Addendum to the Waters Micromass Q-ToF Premier Mass Spectrometer Operator's Guide

715001174/Revision A

This addendum details changes that have been made to the Waters Micromass Q-ToF Premier Mass Spectrometer Operator's Guide (71500089402 Revision B).

Gas connections on rear panel:

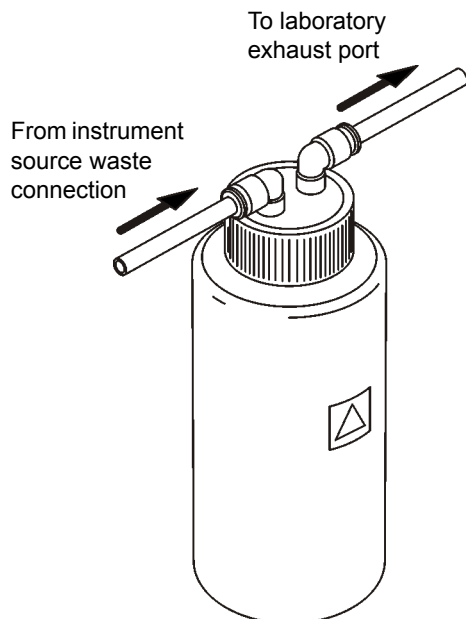
Delete the existing “Gas connections on rear panel” figure and replace with the following:

Source enclosure door:

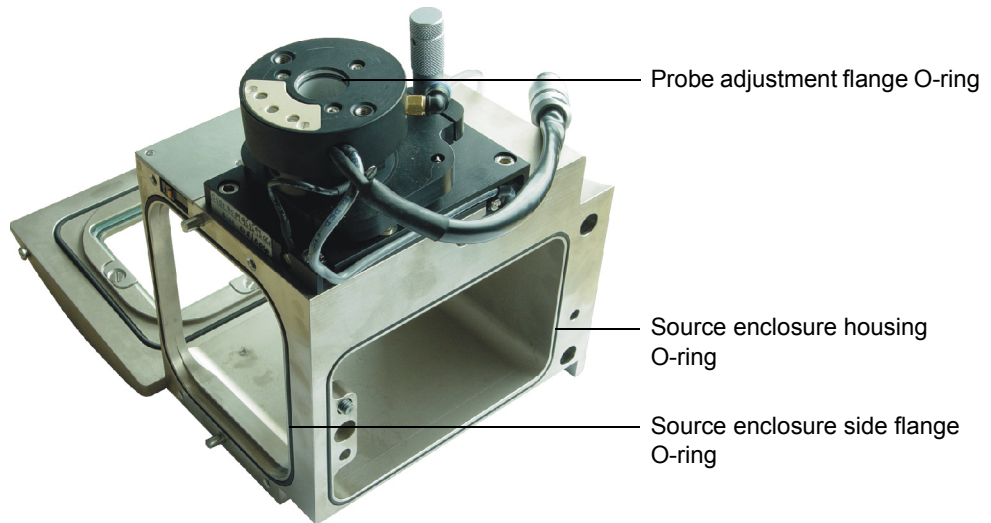
Add the following section after the “Safety and handling” section:

Replacing the LockSpray modular source enclosure, probe adjustment flange, and source option O-rings

Nitrogen exhaust waste bottle:

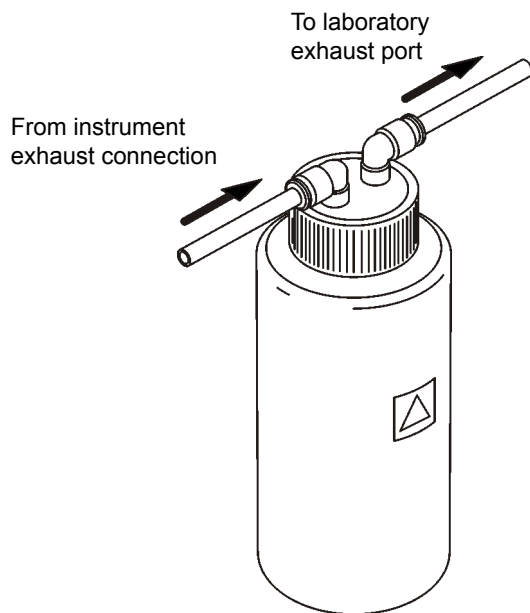
Add the following section after the “Replacing the LockSpray modular source enclosure, probe adjustment flange, and source option O-rings” section:

The nitrogen exhaust waste bottle in the nitrogen exhaust line must be emptied before it is completely full.

APPI lamp drive assembly:

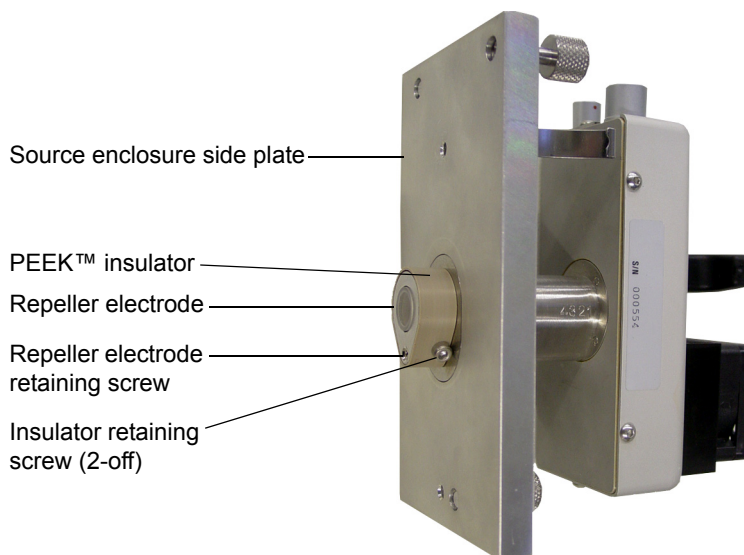
Delete this section and replace with the following:

Changing the UV lamp bulb
